I am writing to summarize initial concerns that have come to my attention upon reviewing Los Alamos National Laboratory's plans for the venting of headspace gases in four Flanged Tritium Waste Containers (FTWCs).

# Summary of Comments on UCS\_Tritium Memo for NMED\_July18\_LANL comments.pdf

Fig. 1: Schematic of venting configuration for FTWC venting procedure. (Hyatt 2022)

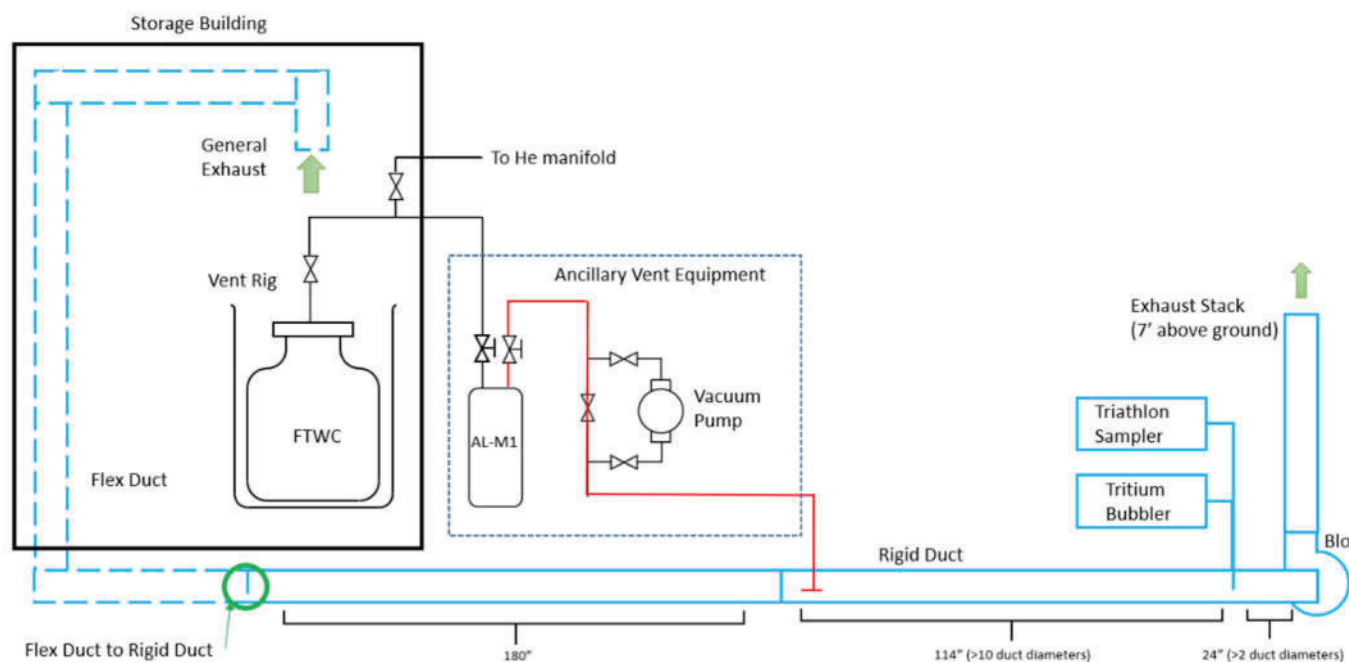
The ‘ancillary vent equipment’ (Fig. 1), which is housed on a portable cart, consists of a vacuum pump which draws gas through an AL-M1 molecular sieve. These sieves may have variable capture efficiency depending on the relative fractions of vapor and gas, which appear to be unknown for each of the four containers. According to LANL, such sieves are credited with ~90% removal efficiency for vapor in a gas stream (dependent on temperature and flow rate). Plans, photographs and an online video indicate that only one will be used rather than several sieves in series, which would seem to be a trivial means of achieving exponential efficiency. To my knowledge, even microporous aluminosilicate sieve media are largely inefficient at trapping hydrogen or tritium gas, which are both small molecules, meaning any gaseous fraction would likely bypass the sieve media with no additional means of capture. While the labs estimate 90% efficiency for vapor, that appears to represent an upper bound according to literature from manufacturers. Molecular sieve media are sometimes employed at very low temperatures (cryosorption) to capture tritium at other facilities, including within the DOE complex (Shmayda 2001; Kawamura et al. 2000), however I’ve seen no indication that low-temperature processes used elsewhere were considered for this procedure.

In addition to employing a single molecular sieve bed, the vacuum pump which draws effluents through the single sieve is vented directly to the environment via the outdoor exhaust stack rather than to a pressure vessel that could theoretically contain much of the gaseous fraction that is not trapped by the sieve.

Number: 1	Author: LANL	Subject: Comment on Text	Date: 8/27/2025 11:04:50 AM
Incorrect. The vacuum pump is there to pressure-test the PMM. Only the pressure within the FTWC provides driving force for the headspace gas to vent out the stack.				
	Number: 2	Author: LANL	Subject: Comment on Text	Date: 8/27/2025 11:15:25 AM
Another AL-M1 would be trivial improvement when the HT elemental gas is unaffected. Very little benefit overall. LANL will ensure the capture system AL-M1 has adequate capacity between each FTWC.				
	Number: 3	Author: LANL	Subject: Comment on Text	Date: 8/27/2025 11:05:37 AM
Cannot bring that level of infrastructure to this site without increasing risk of vibration/shock/ignition				
	Number: 4	Author: LANL	Subject: Comment on Text	Date: 8/27/2025 11:20:47 AM
The pump configuration details are not technically accurate, and would still have ignition concerns with hydrogen/oxygen mix.

Fig. 2: Photographs of the hardware produced for the venting procedure. (NNSA 2022)

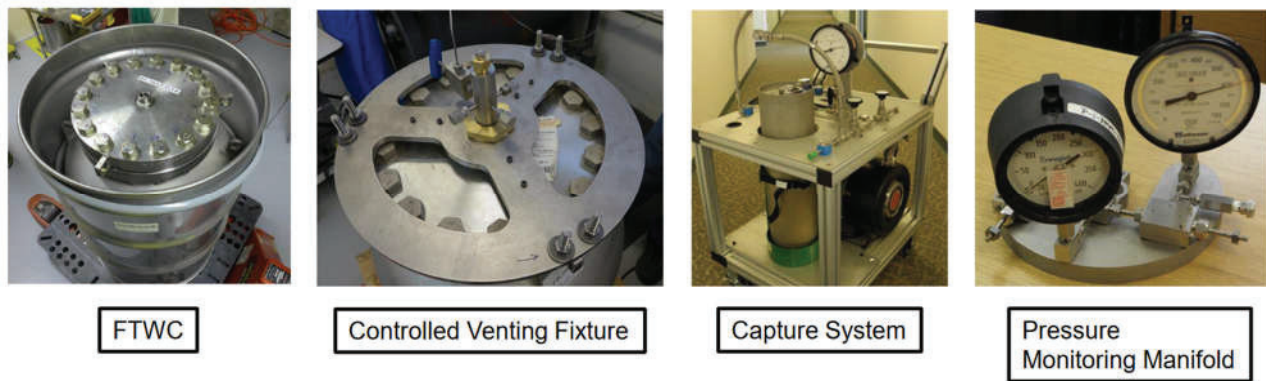
Upon reviewing information describing LANL's proposed approach for <sup>1</sup>penetrating the set of four FTWC's at TA-54 to reduce headspace pressure, I am struck by the apparent paucity of engineering controls being planned to mitigate accidental release. Schematics (Fig. 1) and photographs (Fig 2) suggest a lack of secondary containment around the FTWC during the venting process, which is the most fundamental level of risk mitigation strategy possible and which, in my opinion, could be <sup>2</sup>included without significant added burden.

The FTWCs sit within 85-gallon overpack drums (which, themselves, provide an opportunity for at least rudimentary secondary containment by employment of a gasketed flange). Documents suggest that a vent manifold will be installed on the FTWC to allow a controlled release through a molecular sieve (capture system) with simultaneous monitoring of release to the atmosphere using bubblers integrated in an overhead exhaust duct and stack (Figs. 1, 2).

<sup>3</sup>Although the schematic and associated description suggest the ability to perform a helium leak check of the system prior to venting (which is good practice), the act of penetrating the FTWC using the vent rig appears to present undue risk given the lack of secondary containment. The same is true for removal of the vent rig and installation of the pressure-monitoring manifold (which appears to exceed the height of the overpack container and therefore render it unusable for transport) (LANL 2022). The associated duct cannot be credited with capture of tritium, particularly in the event of an accident. The illustrated ductwork can only provide partial monitoring of potential leaks throughout the process and a modest amount of worker protection.

Penetrating is misleading. We are using engineered systems to relieve the pressure in a controlled manner.

Introduces adding to vibration/shock/ignition risk.

The vented headspace will be a separate line directly into the vent cart, control system, and monitored stack.

General exhaust provides about one air change per minute in bldg 1028 which is more than adequate for capturing potential releases that could bypass vent system (highly unlikely/remote)
